SERVICE BULLETIN

Classification: HA17-007	Reference: NTB17-116	Date: November 16, 2017
-----------------------------	-------------------------	----------------------------

2016-2017 TITAN AND TITAN XD; EXCESSIVE VENT TEMPERATURE DIFFERENCE IN DUAL CLIMATE CONTROL MODE WITH THE SAME TEMPERATURE SETTING

APPLIED VEHICLE: 2016-2017 Titan and Titan XD (A61) with dual climate control air conditioning

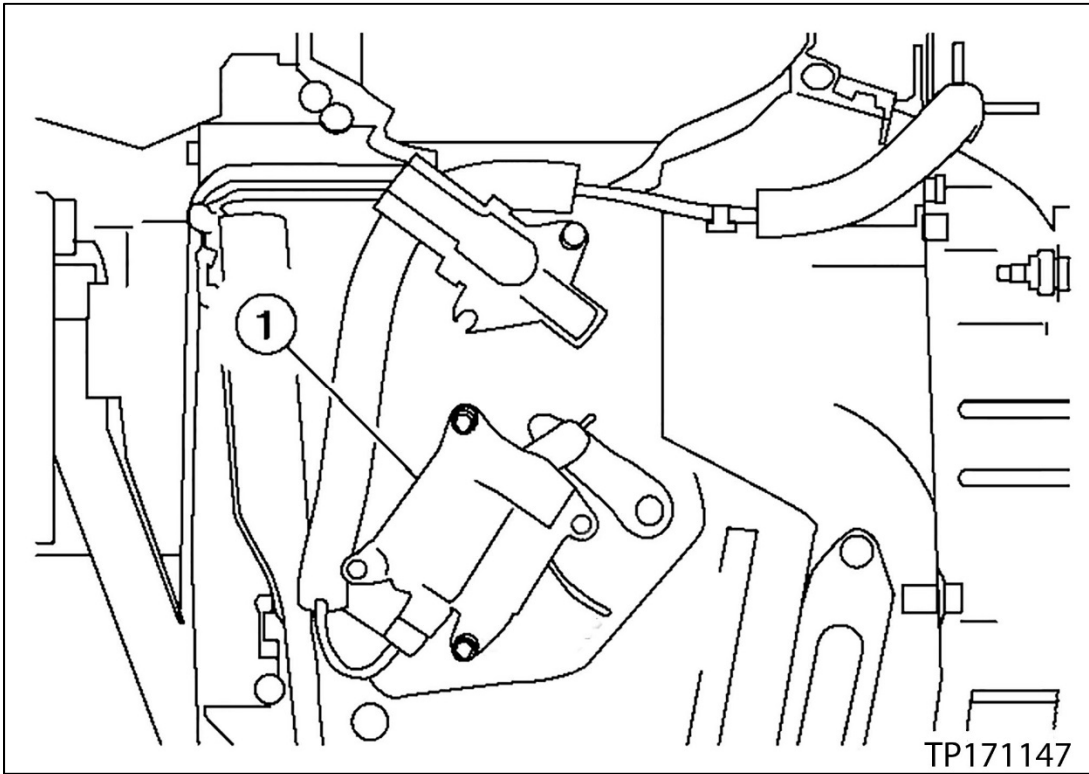
A. Temperature set for cool air: The outlet temperature of the driver side vents are warmer by 10°F or more than the passenger side vent temperatures

B. Temperature set for warm air: The outlet temperature of the passenger side vents are cooler by 10°F or more than the driver side vent temperatures.

1. If **A** above is occurring: Replace only the driver side air mix door motor (see Parts Information).
 - Refer to the Electronic Service Manual (ESM), section HAC-Heater & Air Conditioning Control System, for driver air mix door motor removal and installation.
2. If **B** above is occurring: Replace only the passenger side air mix door motor (see Parts Information).
 - Refer to the Electronic Service Manual (ESM), section HAC-Heater & Air Conditioning Control System, for passenger air mix door motor removal and installation.
